MELIADINE GOLD MINE PROJECT

ENGINEERING CHANGE NOTICE

Design Change of Dike Liner Key-in Detail at Crest for D-CP1 and D-CP5

ECN Title: Design Change of Dike D-CP1 Over-Liner Bedding (replacing a zone of Type C with Type F)

TYPICAL LINER KEY-IN AT CREST - PREVIOUS DESIGN

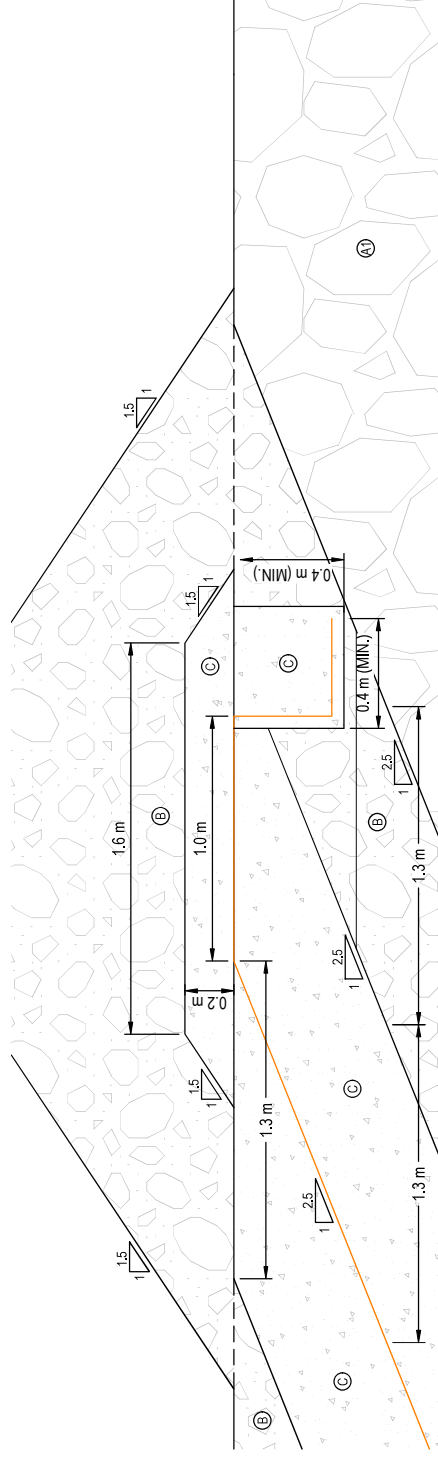
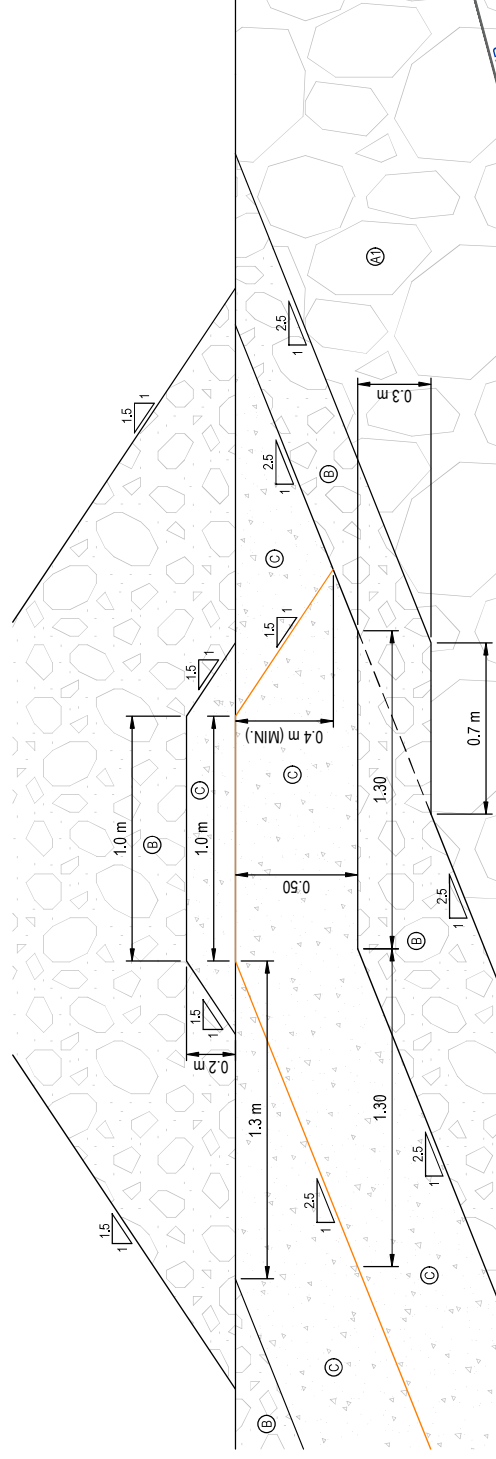
In the meeting with Luciano and Duy on October 28, 2016, Luciano suggested some changes to avoid sharp corners of the liner in anchoring the liner over the dike crest. As directed, we have prepared two drawings (see attached) to show the proposed design changes for your review:

- 1) Proposed dike crest design change No.1 for D-CP1.
- 2) Proposed dike crest design change No.1 For D-CP5.

As suggested by the extremal reviewer (Luciano), minor changes to the dike liner key-in at crest were made to avoid sharp corners of the liner in anchoring the liner over the dike crest.

TYPICAL LINER KEY-IN AT CREST - REVISED DESIGN

NOTE:
ADDITIONAL MATERIAL 'C' CROSS-SECTIONAL AREA = 0.330 m²
ADDITIONAL MATERIAL 'B' CROSS-SECTIONAL AREA = 0.110 m²

FIGURE 1 OF DESIGN CHANGE ECN 003 FOR D-CP1

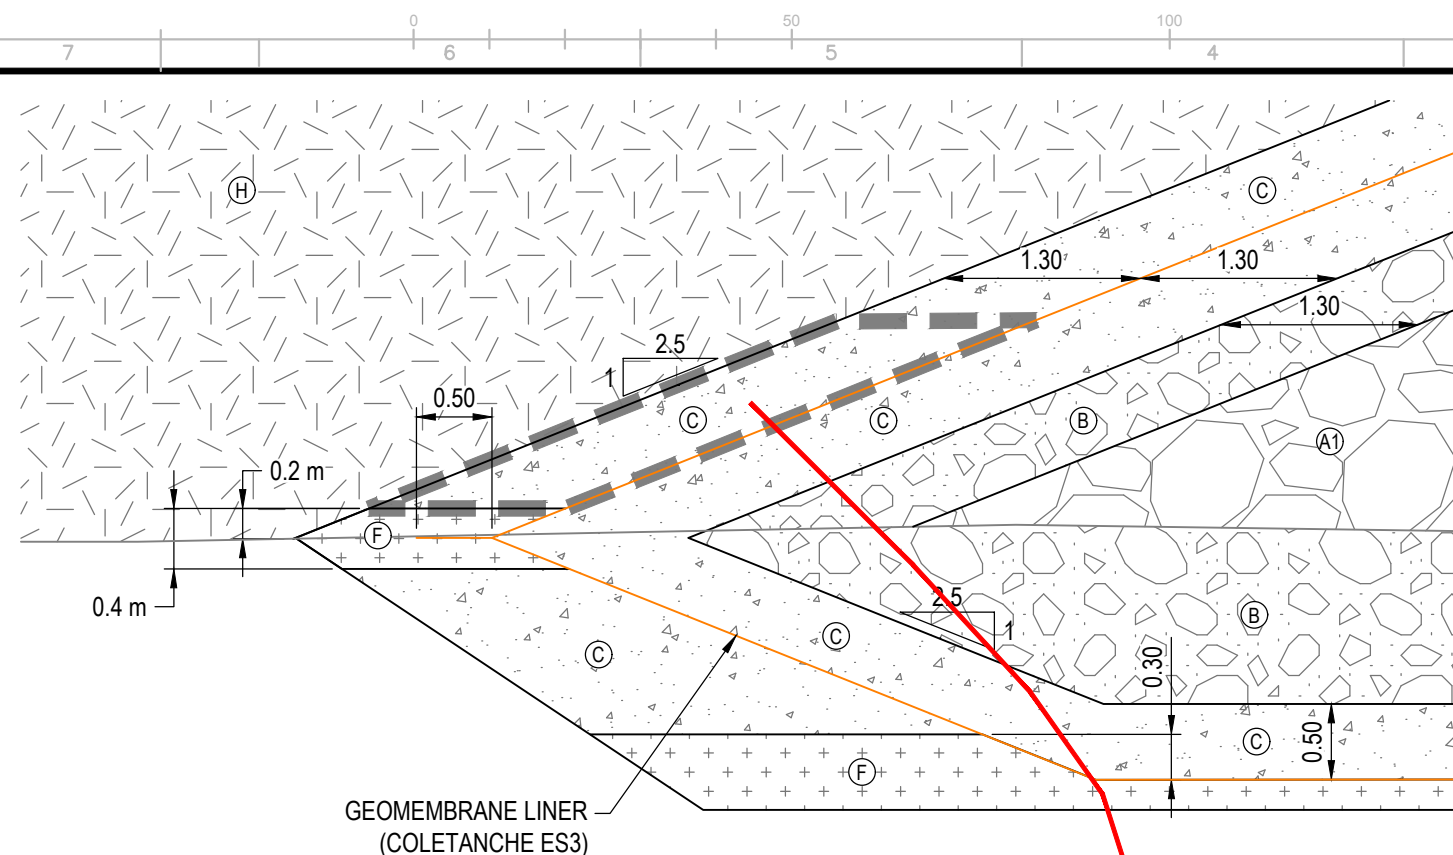
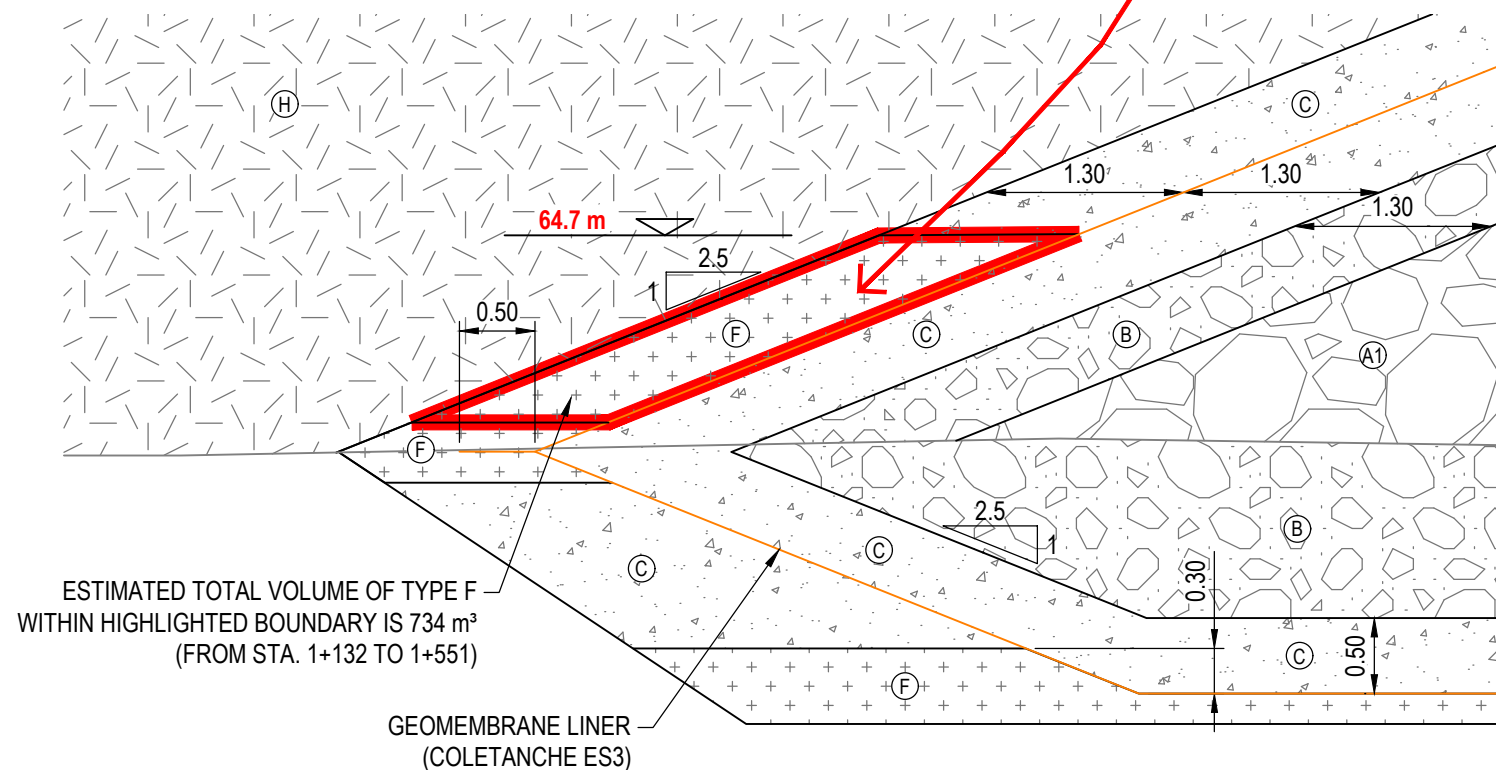
D-CP1 TYPICAL SECTION - CURRENT DESIGN
SCALE: 1:50

D-CP1 TYPICAL SECTION - PROPOSED DESIGN CHANGE
SCALE: 1:50
